# EXISTING

## PROPOSED

# ABILITATION GROUP 3 ROSEDALE 2, RTU 360

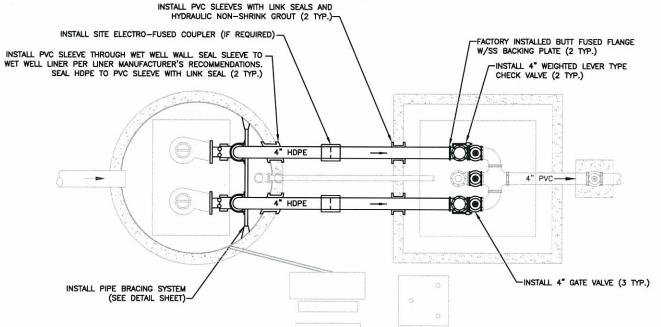
DATE	1/22/1						
	Α	SSC						
	REVISION DESCRIPTION	ADDED 3 SS PIPE SUPPORTS						
- INSTALL SS ADJUSTABLE PIPE SUPPORTS (3 TYP.)	Ñ.	-						
2 MIN.). TOP BE 4' ABOVE		PROJECT # 402-0 500 SURVEY #			0019707 01334			
		SEC./TWN./RGE 22/35/					8	
11111	11 lep	STALE       N.T.S.						
	4W	S. S. BY DATE						
11. 15	DE	SIGNE	36	JE	2	827	2011	
= */	N SPRENCE STATE OF P.E. A SHEET 8 (				,	04/2011		
TO I		MJOHN S. SHOUN, A.E.						
三人	STA	r#9	gp.	P.E.	# 5	0923	25	
	A) -		2		N.	A		
1100	;:49	YORIDAGIN						
BOLTS; MAY ELL MOUNTING	,9 <u>w</u>	WAL ENTIN						
,	′′/ <del> </del> ੁ	SHEET 8 OF 12						
	15	HL	_	8	OF	-	/

- INSTALL SS PIPE BRACING SYSTEM WITH LATERAL SUPPORT, (2 MIN.). TOP BRACE TO BE WITHIN 2' OF TOP ELBOW. LOWER BRACE TO BE 4' ABOVE BASE ELLS. MAX SPACING OF 8' BETWEEN BRACES.
